**THE REGIONAL MUNICIPALITY OF YORK**

**Request for Tender No. T-19-349 Addendum #1**

**For:** Interior Renovation – 3<sup>rd</sup> Floor Block A, B, & D at the York Region Administrative Centre

ADDENDUM

A602

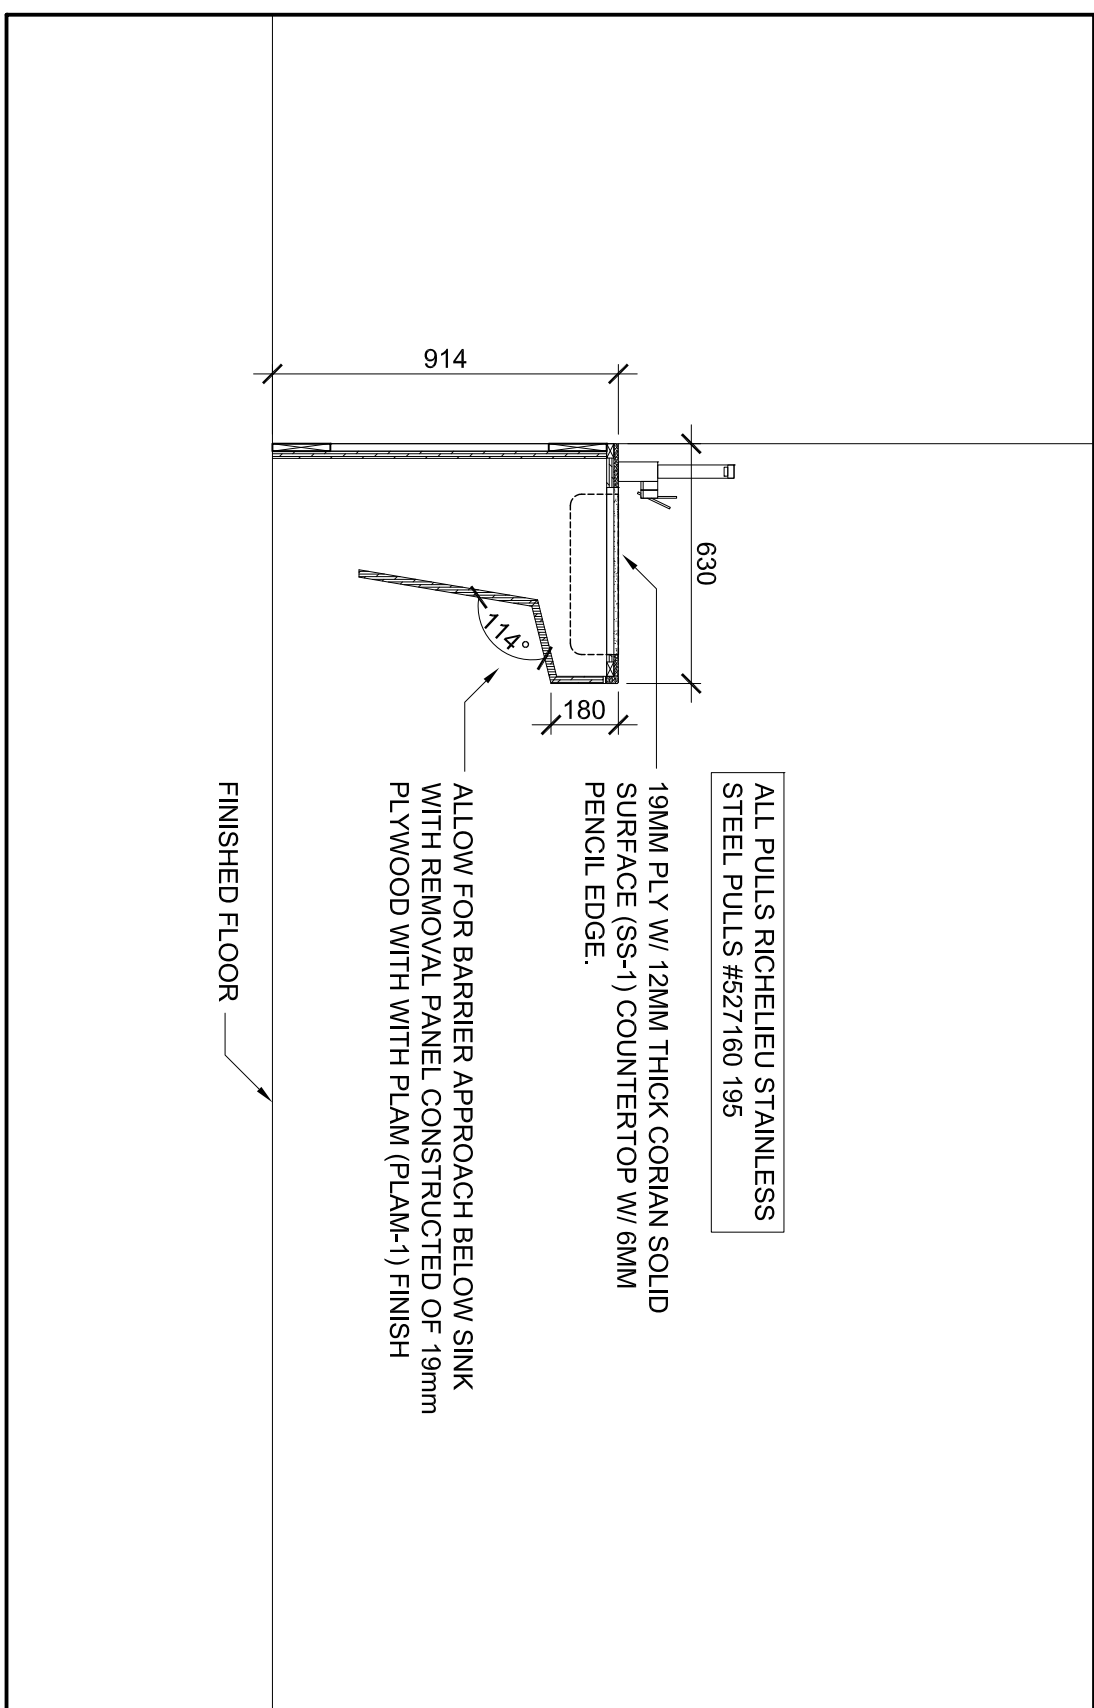
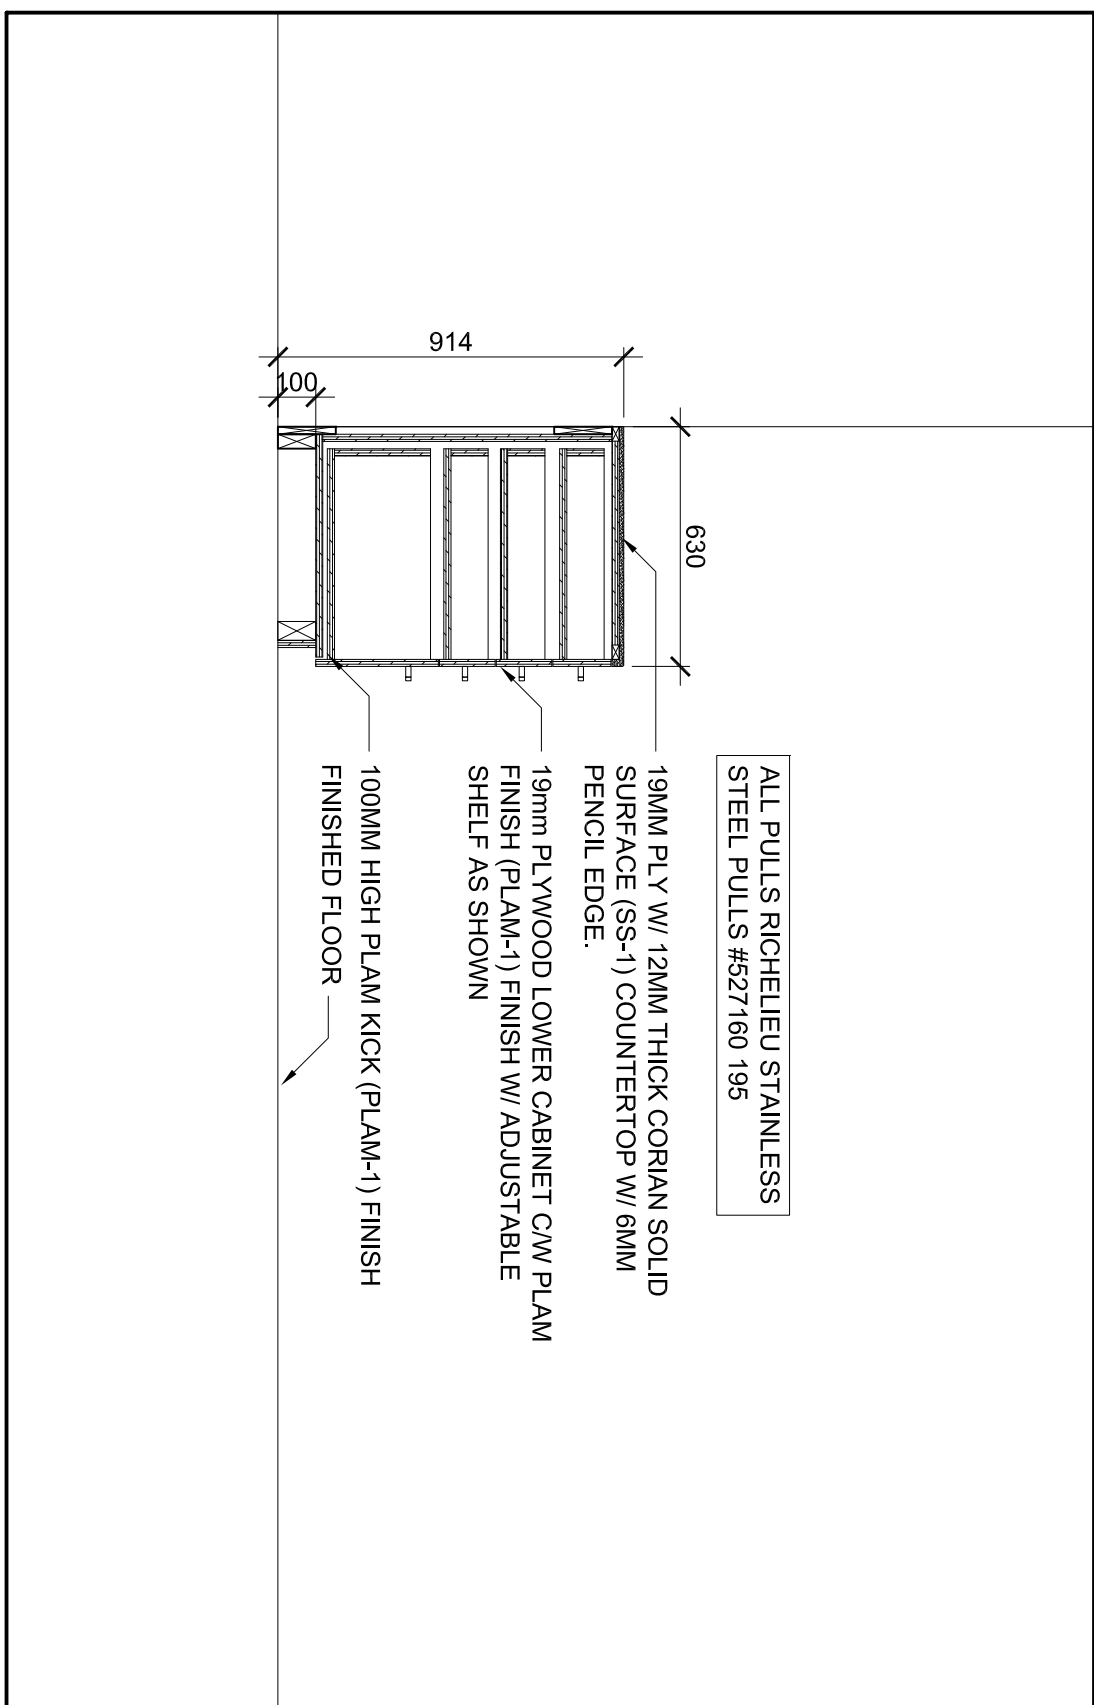
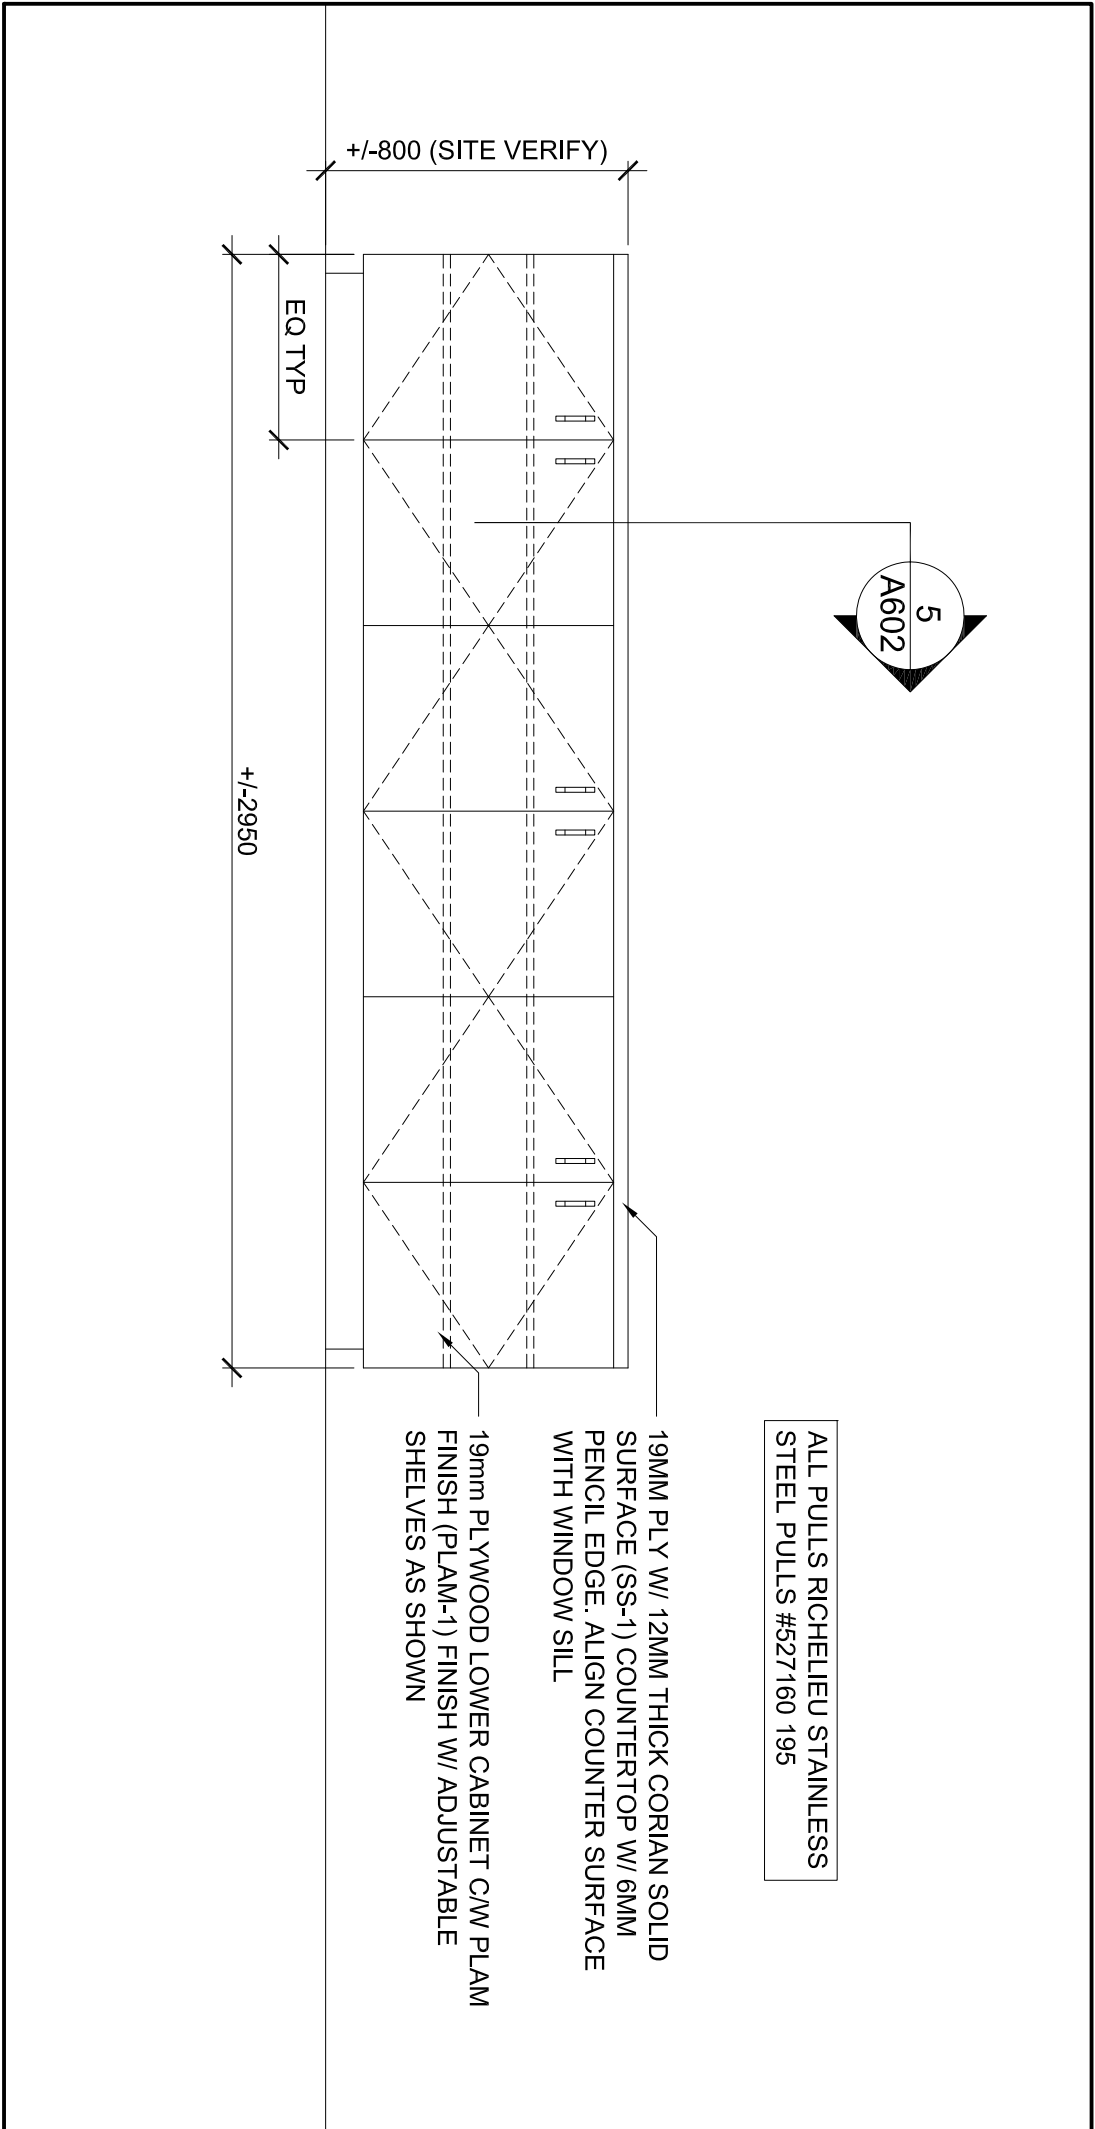
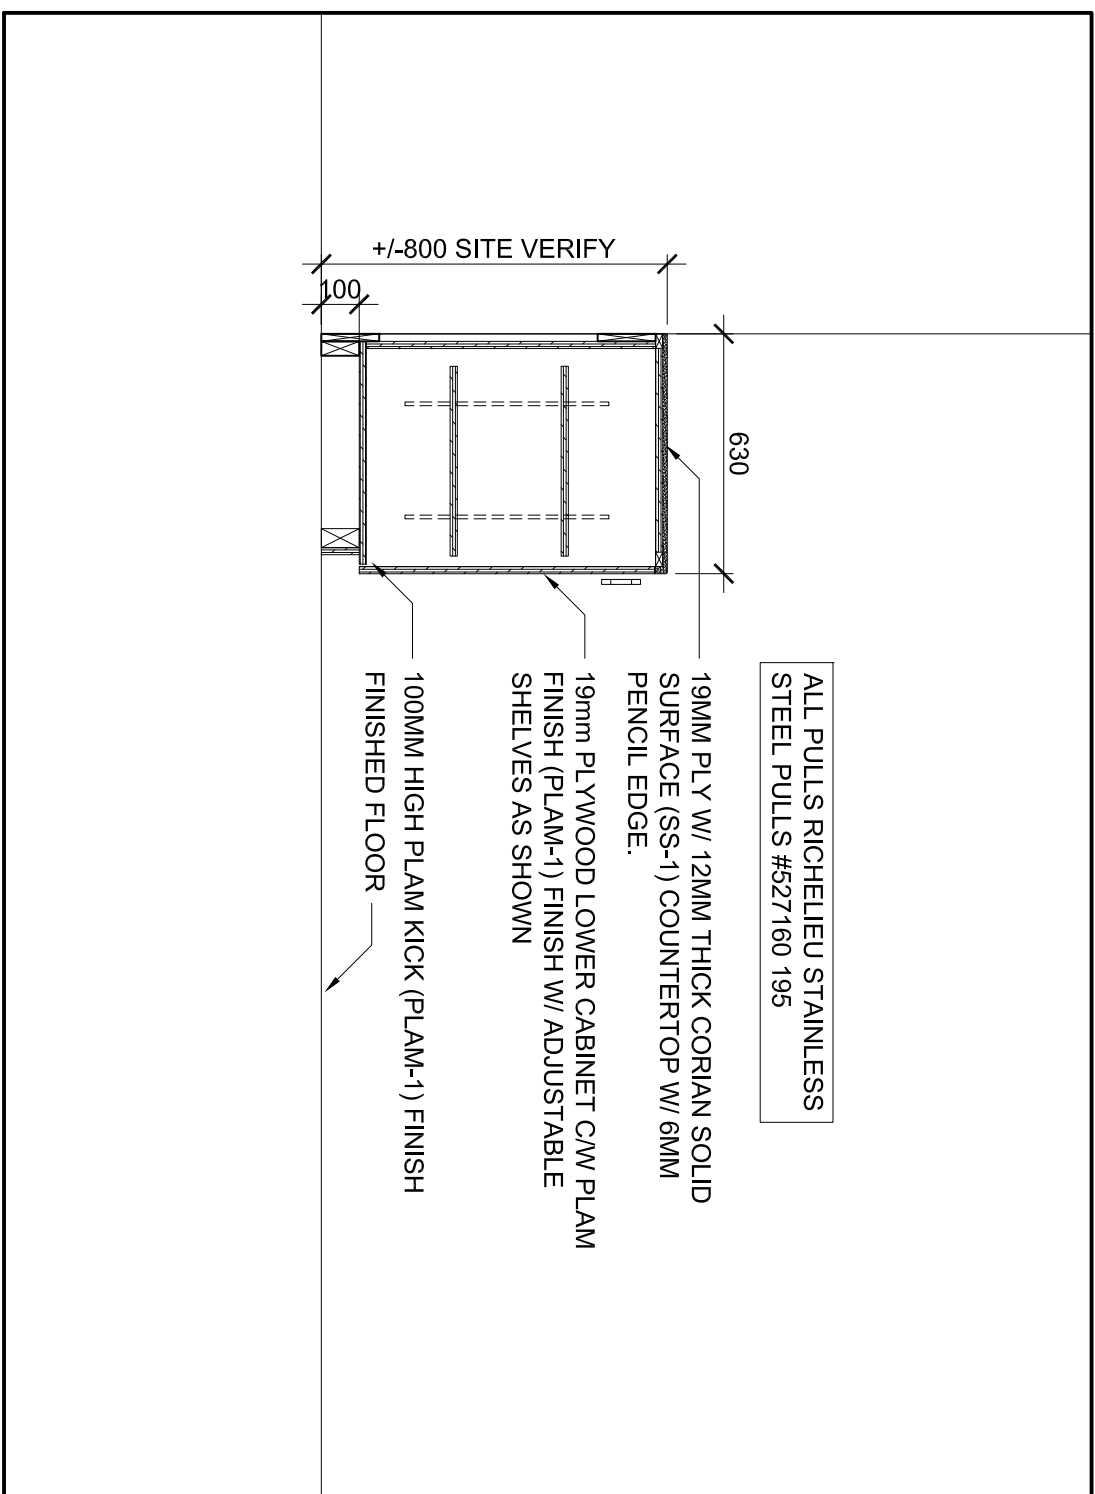
Q29. Any millwork detail for Meeting Room 3-88?

**A29. Yes, refer to attached revised drawing A200 and new detail Drawing A602.**
